McMILLAN SAND FILTRATION SITE COMMUNITY CENTER & PARK DESIGN UPDATES

COMMISSION OF FINE ARTS SUBMISSION

4 MAY 2023

McMILLAN COMMUNITY CENTER LANDSCAPE DESIGN UPDATE

Figure 4: McMillan Memorial Fountain updated location enlarged plan

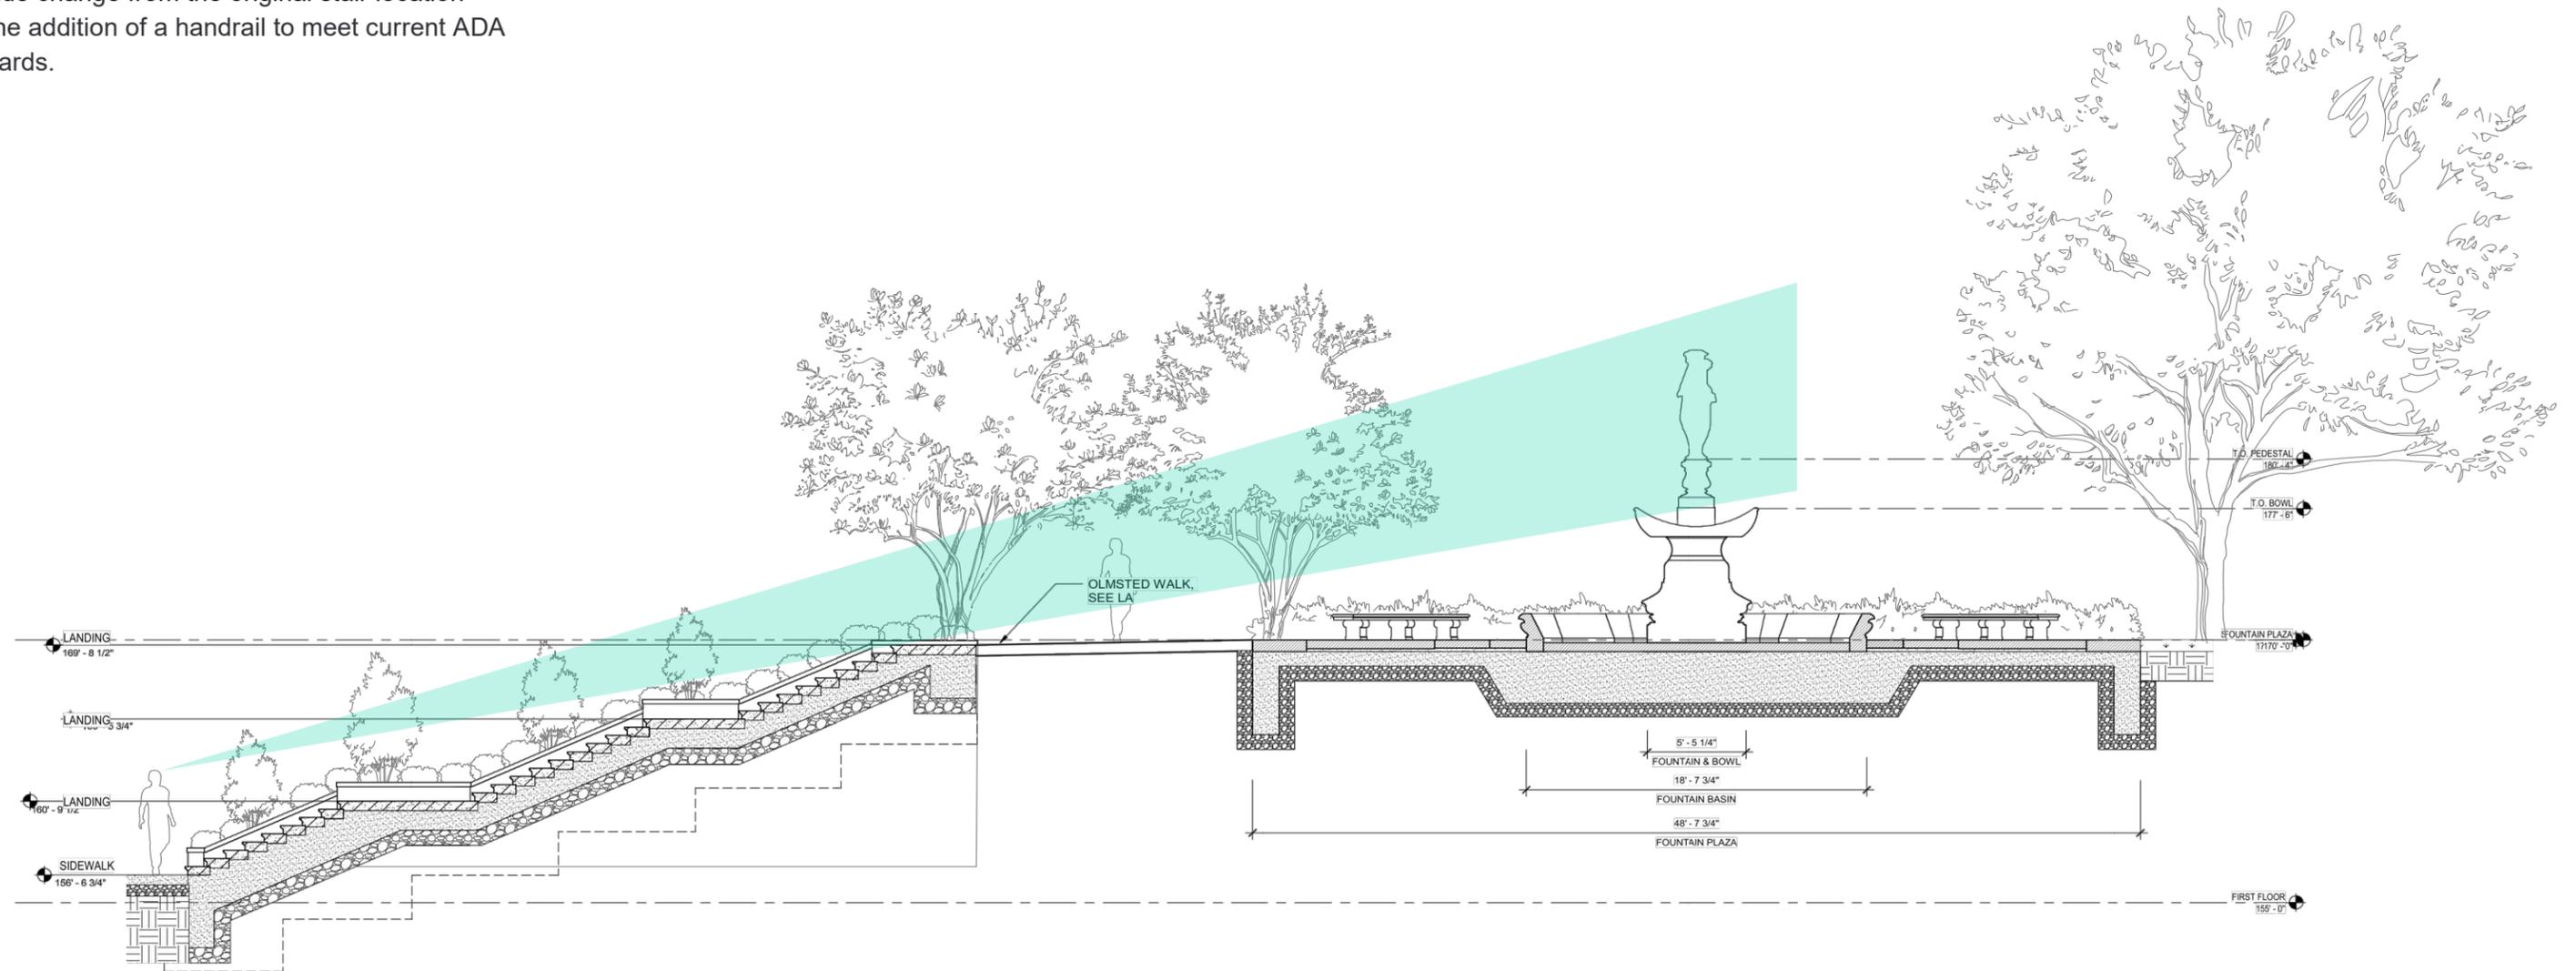
The McMillan Memorial Fountain, its stone plaza, and the original stone steps are proposed to be installed in a new location, just north of the southwest corner of the site.

When presented to the Commission of Fine Arts in June 2020, the fountain and plaza were shown at the southwest corner, with the stairs descending to the intersection of Channing and First Streets. This design was based upon recommendations made in the 2016 McMillan Sand Filtration Site Historic Preservation Plan by EHT Tracerics. That document stated (page 87) that the "large existing tree at the corner of First and Channing is not part of the historic planting of the Site, and should be removed." Because the tree has a circumference of greater than 100 inches, it is designated a "heritage tree." As such, the Owner has elected to preserve the tree rather than remove it. Engineering solutions to adapt the stone steps so that they could bridge over the critical root zone of the heritage tree were unsatisfactory to ensure that the tree would survive construction.

As a result, the design team has developed an alternative location for the McMillan Memorial Fountain and its associated stone steps and plaza paving. This revision relocates the fountain and its 2,000 square foot stone plaza forty feet north of the location shown in the 2020 submission to the Commission of Fine Arts. It reorients the rehabilitated stairs to descend from the fountain to First Street perpendicular to the north-south face of the westernmost berm rather than on the diagonal to First and Channing Streets. This revision restores the original alignment of the McMillan Memorial Steps along the face of a berm rather than at the intersection of two perpendicular berms. The relocation also changes the relationship of the

fountain to the Olmsted Walk: When shown to the Commission of Fine Arts in June 2020, circulation along the Olmsted Walk at the southwest former of the site passed through the fountain plaza via two 45-degree bends in the paved walk. By moving the plaza north of the southwest corner, the Olmsted Walk is now completely separate from the fountain plaza. A five-foot length of stone paving will serve as the transition from the Olmsted Walk to the fountain plaza. This offset allows the plaza to be more quiet and contemplative than the former condition where the Walk passed through the space.

The design has been further updated to provide two flanking plazas, one to the north and one to the south of the rehabilitated plaza. These will be smaller than the fountain plaza, and surfaced with compacted crushed granite edged with flush granite bands. Movable tables and chairs will be provided to encourage flexible use of these two seating areas.

Cross section B showing updated location of steps and plaza along westernmost berm. Note cone of vision from First Street to fountain.

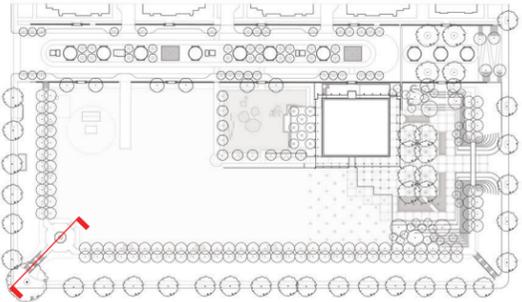
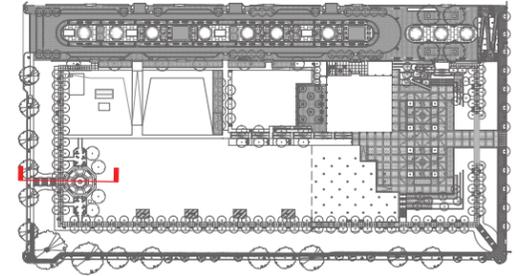
Adaptations to the original design include reducing the overall number of steps to account for the difference of grade change from the original stair location and the addition of a handrail to meet current ADA standards.

Figure 8: 2023 updated plan showing length of run at stone steps, distance from top landing to center of fountain plaza, and width of plaza (NTS)

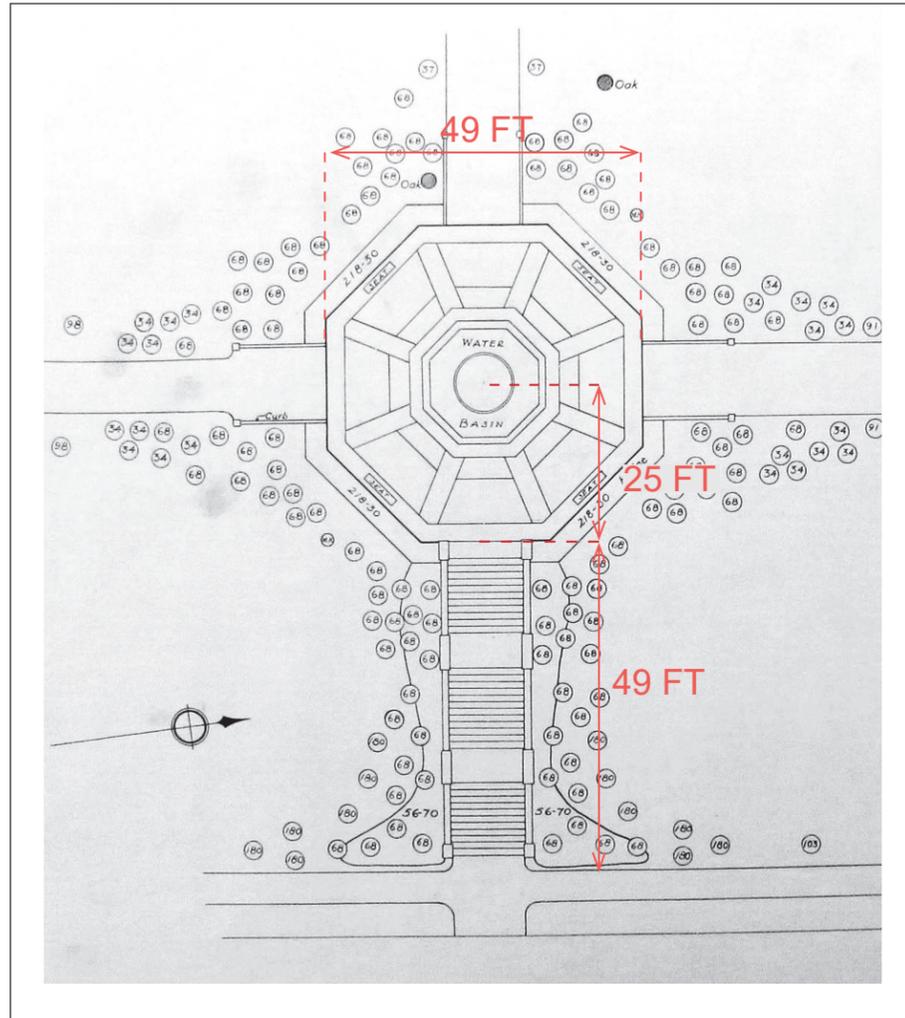
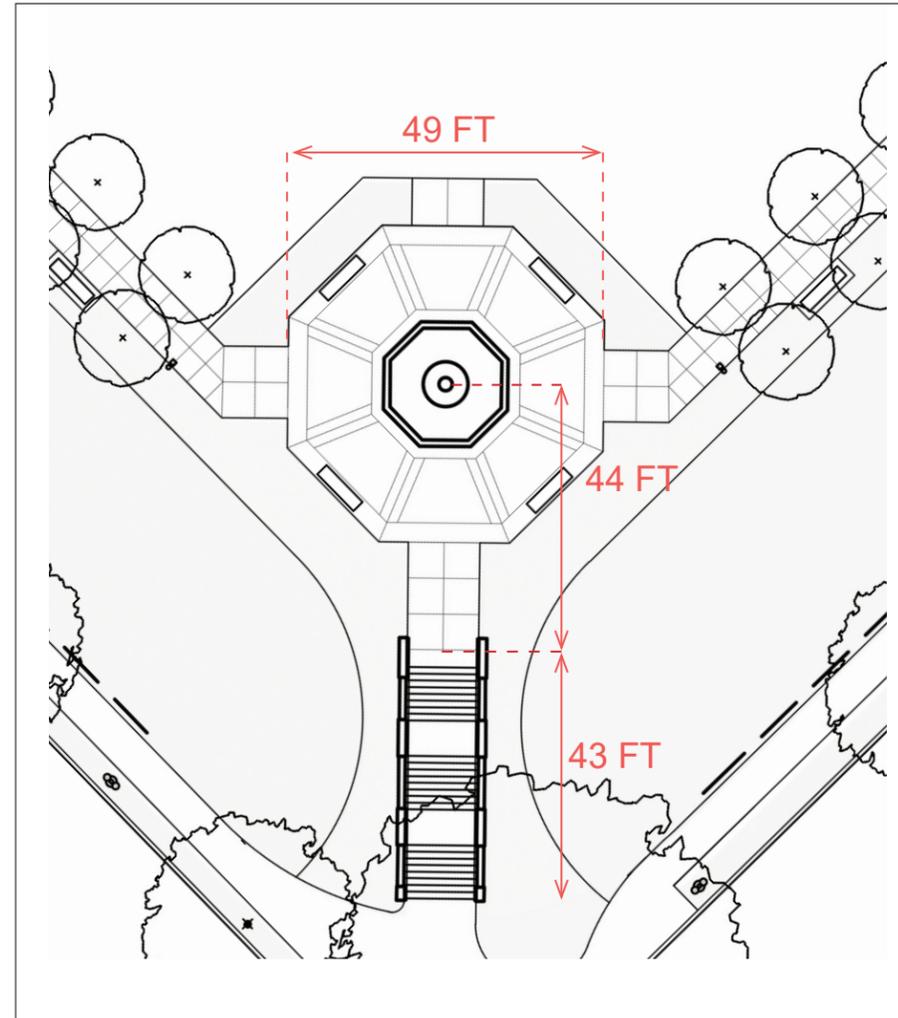
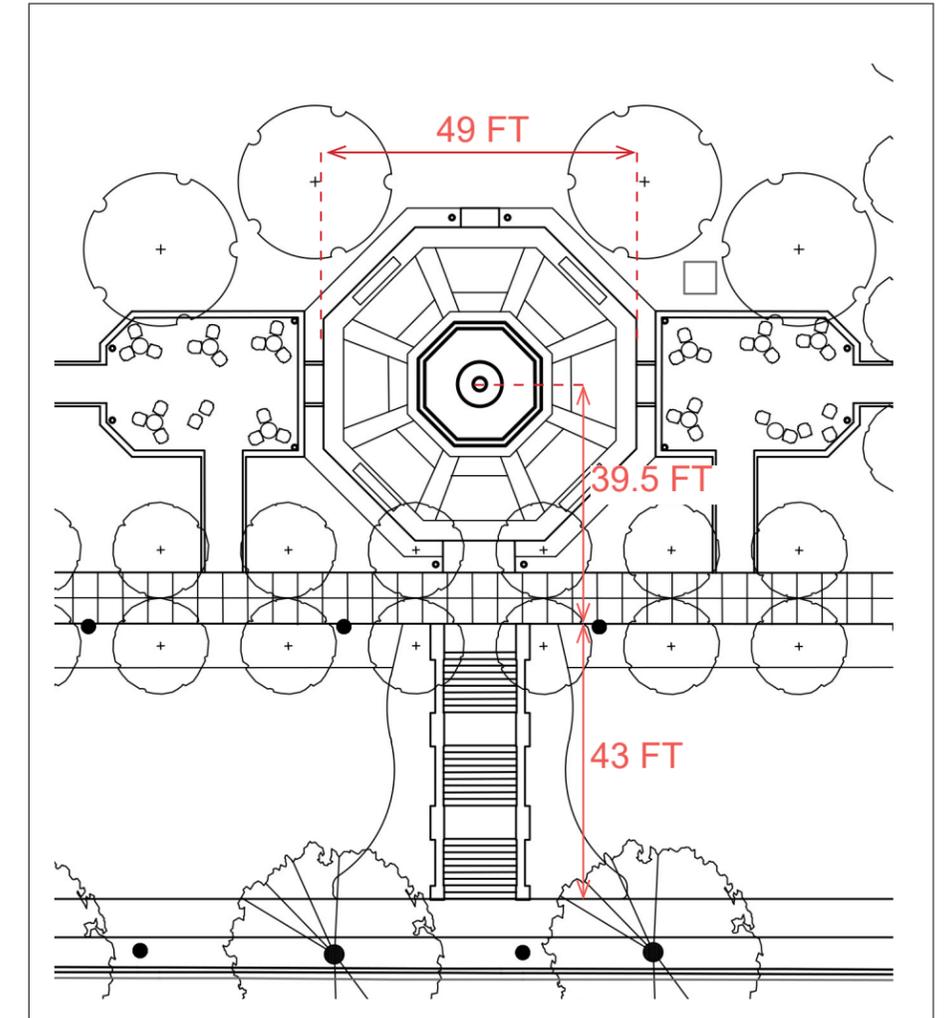
crushed gravel surfacing will be installed. This surfacing will be edged by an 12-inch-wide flush granite band. Movable tables and chairs will be provided in these two plazas to facilitate flexible programming and to establish a counterbalance to the more formalistic nature of the historic plaza. Shade trees will be planted to the east of these plazas to visually and physically buffer this area from the recreational field beyond. The plazas will be offset from the Olmsted Walk and its alignment trees so that the plaza and seating areas will be distinct from the circulation path. From this new vantage point, the fountain plaza and the flanking seating areas will access exceptional views of the McMillan Reservoir and Howard University to the west and of the Washington Monument and the District skyline to the southwest. Figures 6 and 8 illustrate the relationship of the steps to the fountain in the original configuration and in the proposed plan.

Figure 9: McMillan Memorial Fountain materials enlargement

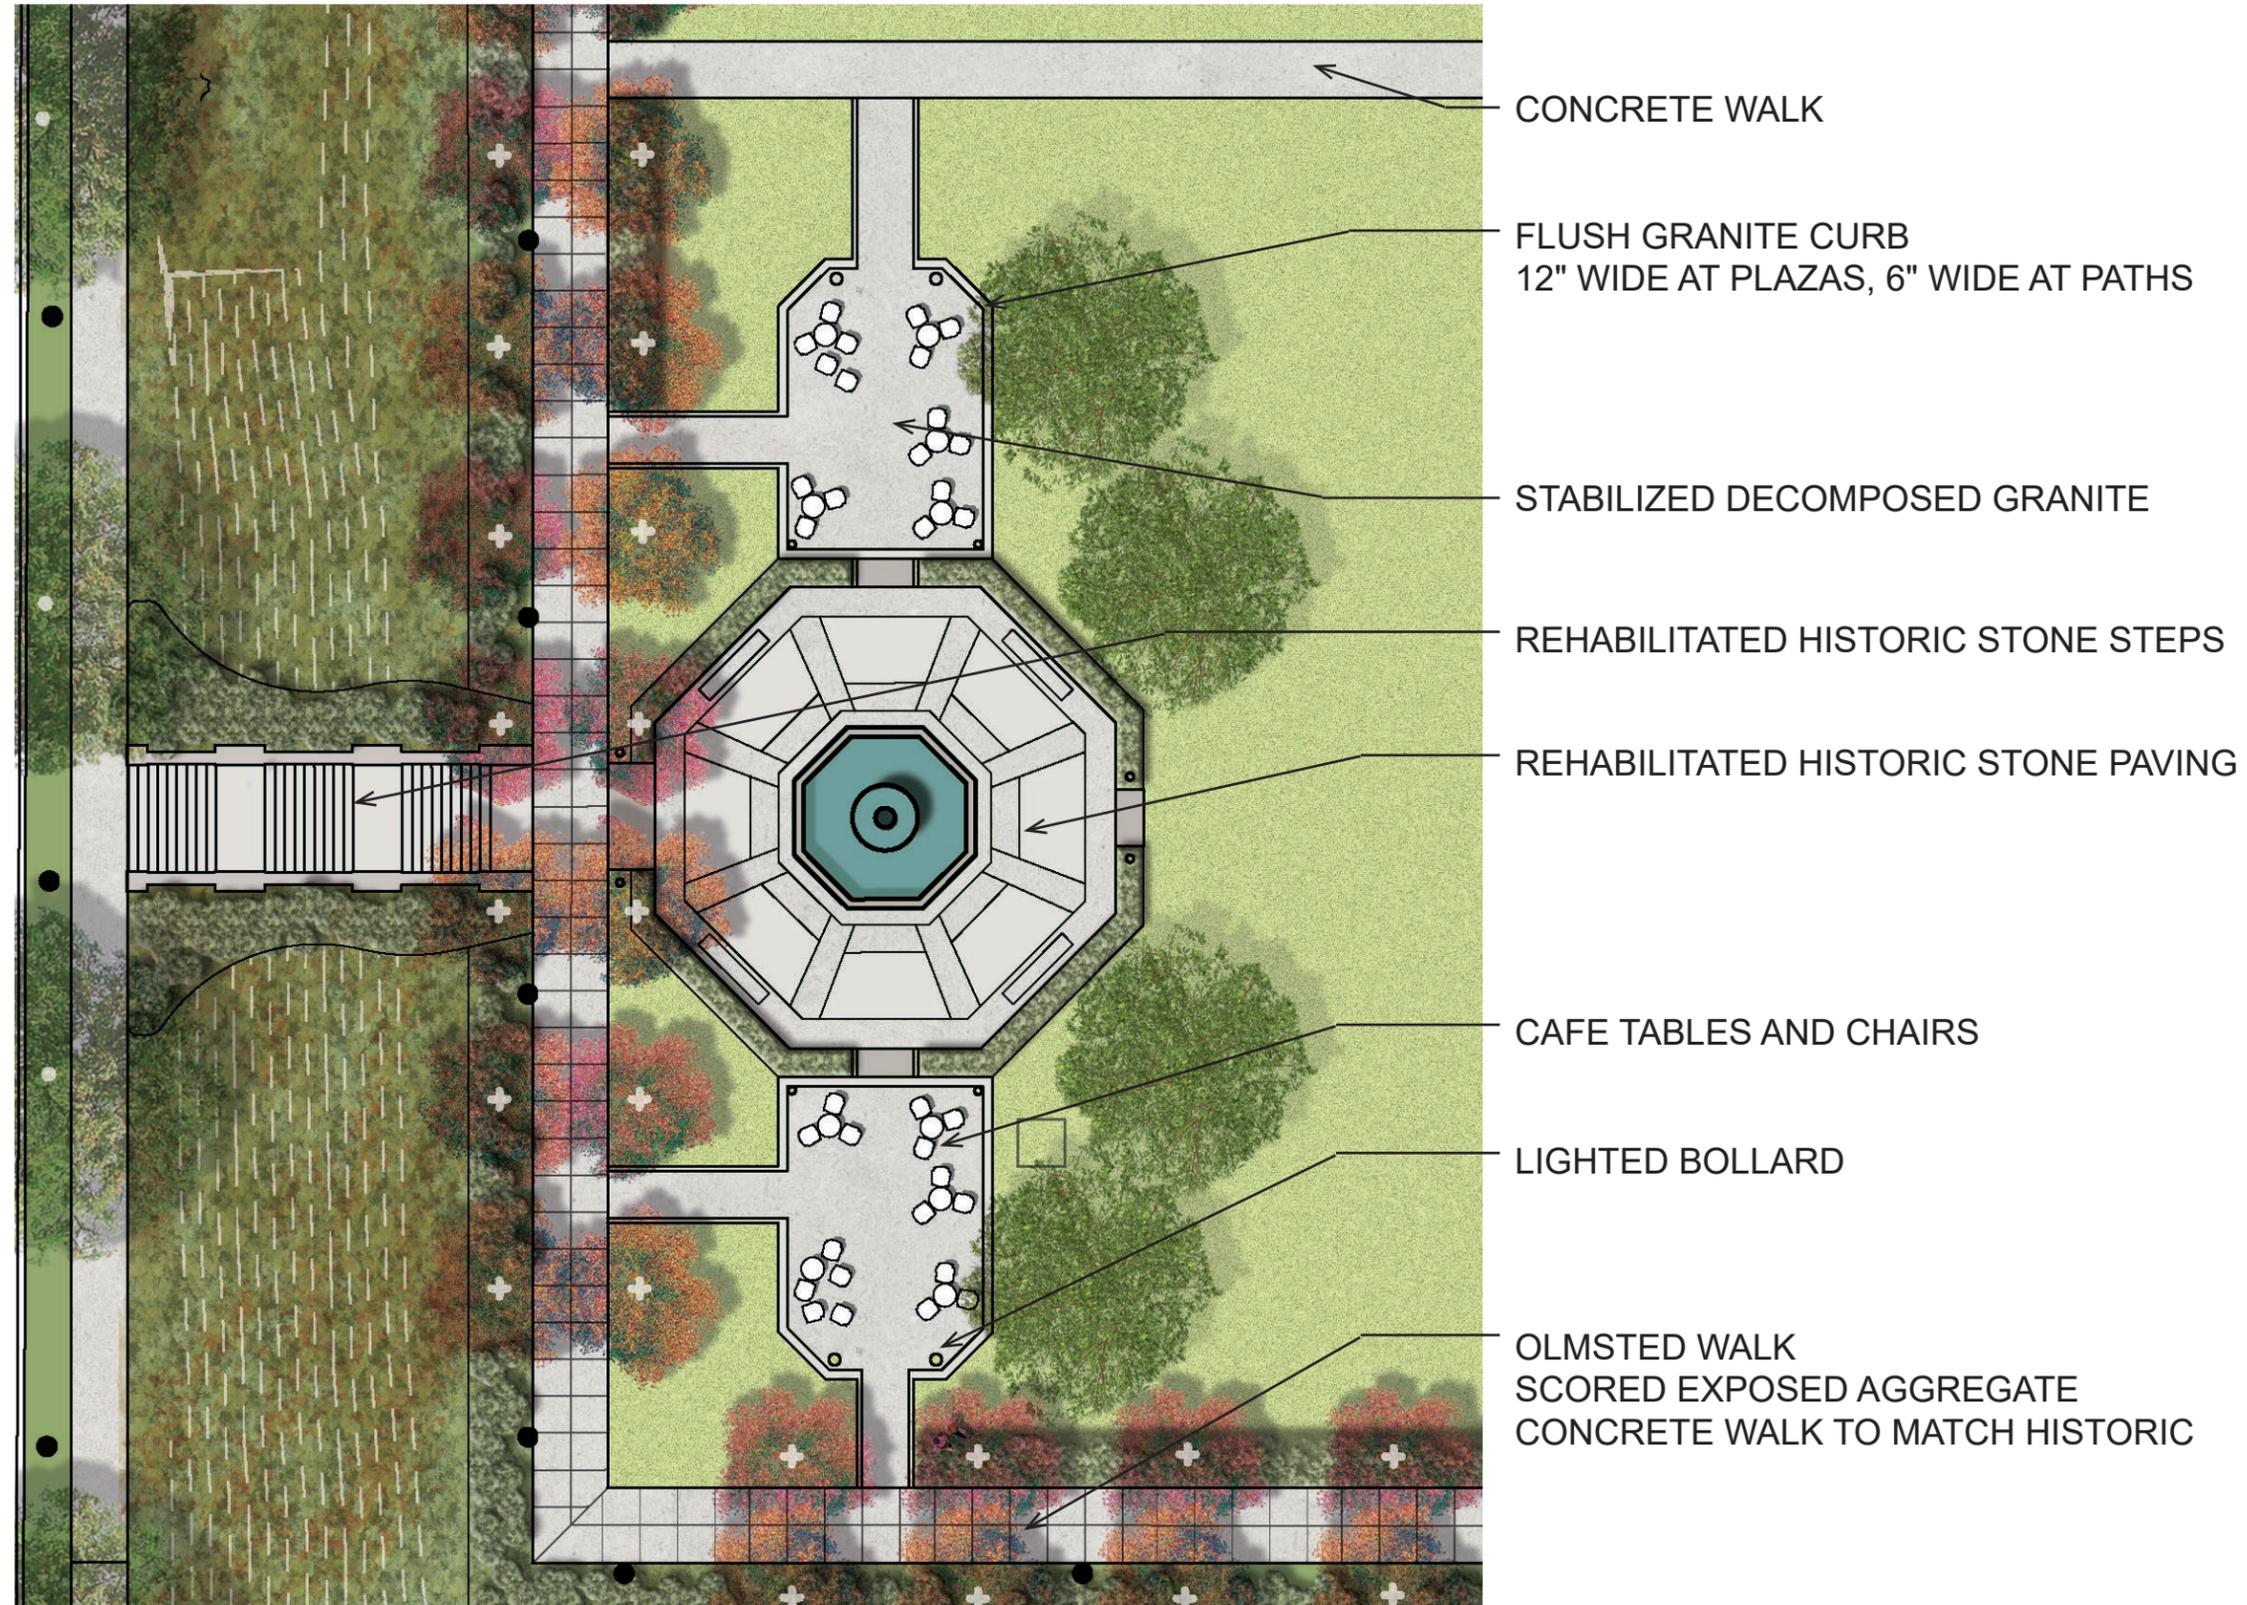
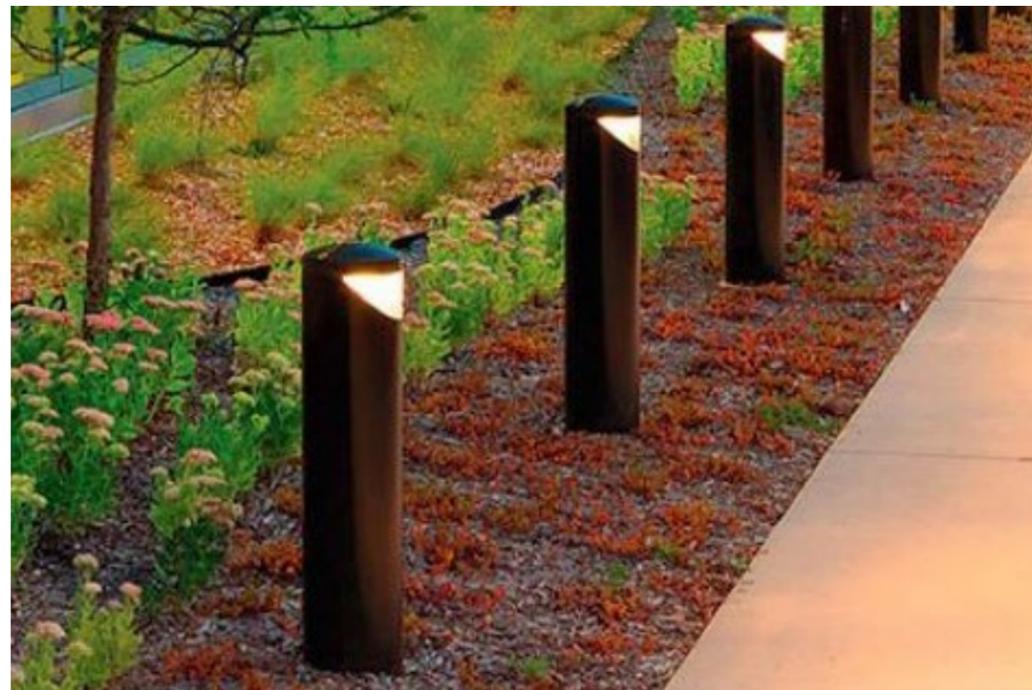
Striving to create an integrated setting for the rehabilitated fountain and its four original stone benches, ancillary seating areas will be added to the north and south of the restored fountain plaza. This intervention formalizes the setting immediately surrounding the McMillan Memorial Fountain to make it more suitable for reinterpreting Senator McMillan's legacy. The rehabilitated fountain plaza will be enclosed by a clipped hedge, as was present in the original planting plan by Olmsted, Jr. To the north and south of the rehabilitated stone plaza, ADA-compliant
